**MODIFICATION REQUEST:
Enfield Intermodal Logistics Centre -
Modification 5
Cosgrove Road, Strathfield South
(MP 05_0147 MOD 5)**

Director-General's
Environmental Assessment Report
Section 75W of the
Environmental Planning and Assessment Act 1979

October 2011

Figure 2: Proposed Modified Layout

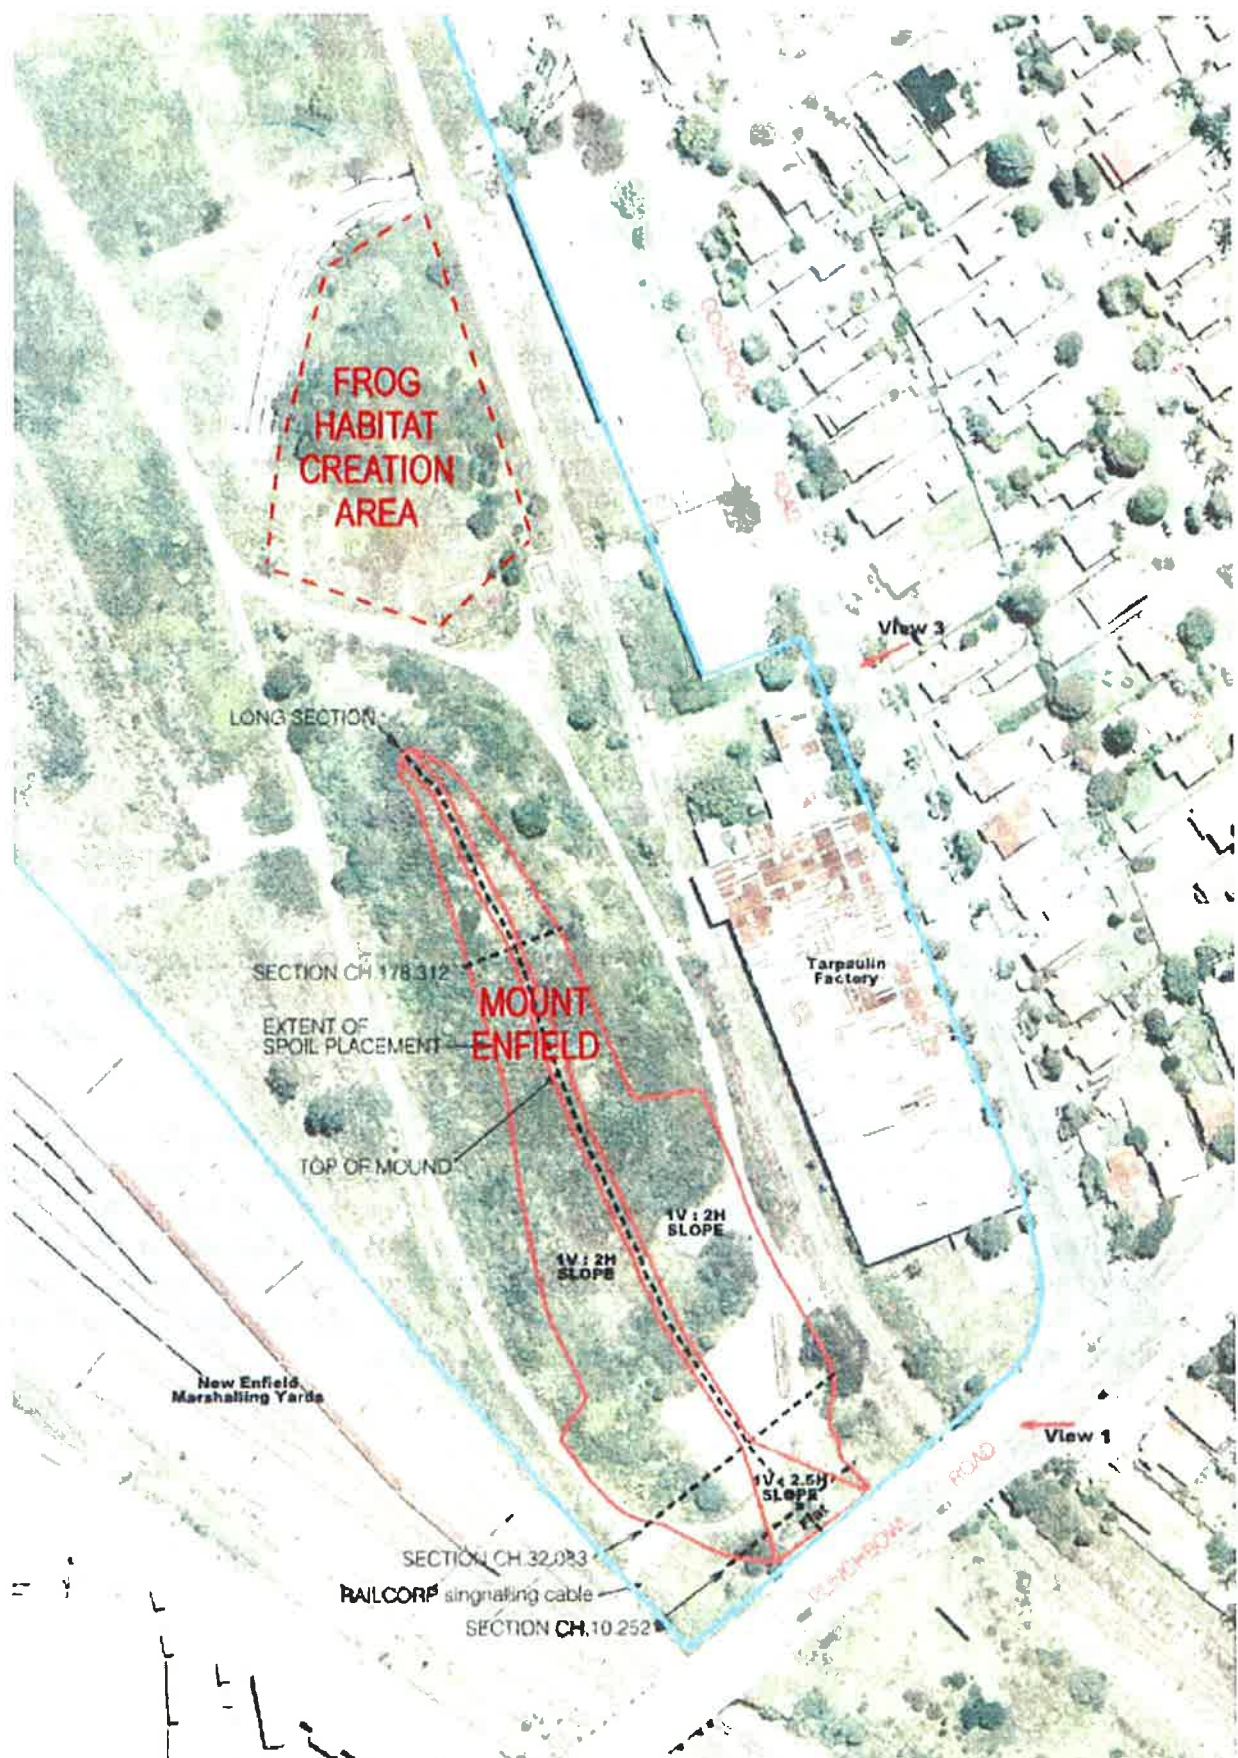
Office of Environment and Heritage – Environment Protection and Regulation Team: raised concern with the gradient of the proposed slope of the filling area, and considered it to be in excess of the recommended slope for stockpiling as detailed in *Soils and Construction: Managing Urban Stormwater* (Landcom 2004). OEH recommended a management plan to manage the steep batters during construction and until stabilised, and provided commentary and recommendations in relation to covering soil, water and dust issues.

Council considered that the proposed mound with its steep slopes should not be permitted, due to high risk of scouring and sediment loss particularly in rainfall events, as the slopes are too steep to accommodate suitable grading for planting. Council also noted that the modification request did not clearly demonstrate where the runoff from the proposed mound would be directed to, and that ponding and flow paths for runoff should be provided to demonstrate that additional runoff volume and velocity had been investigated and allowed for. Council noted that drainage from the site needed to be controlled so that there would be no additional stormwater leaving the site at each point of discharge than occurred prior to the proposed development.

The Department notes concern raised by OEH and Strathfield Council regarding the steepness of the slope and the subsequent stabilisation issues including that it may be too steep for planting and pose scouring and sediment loss impacts during rainfall events.

The Department notes that *Soils and Construction: Managing Urban Stormwater* recommends a maximum of 1V:2H slopes for stockpiles, and notes that rehabilitating steeper slopes of >1V:2.5H by vegetative means can be difficult, but provides guidelines for additional methods to allow for the effective stabilisation of steeper slopes.

The Department notes that Strathfield Council raised concern regarding the detail of drainage of the site, including that ponding and flow path areas for runoff should be provided to demonstrate that the additional runoff volume and velocity has been investigated and allowed for. Council considers drainage from the site needs to be controlled so no additional stormwater leaves the site at each point of discharge than occurred prior to the proposed development.

The Department therefore recommends a condition of approval requiring preparation of a Mt Enfield Stabilisation Management Plan to specifically address management of the steep batters of Mt Enfield during construction and until such time as it is stabilised with vegetation. The stabilisation plan is also required to include consideration of soil, water and dust issues.

recommended a specific condition of approval for the preparation of a Mt Enfield Stabilisation Management Plan. This Plan outlines requirements for specific performance criteria, including that any associated increase in flow velocity is provided for so that it does not exceed current rates, and that ongoing management of drainage structures and landscaping are considered in the project's Operation Environmental Management Plan.
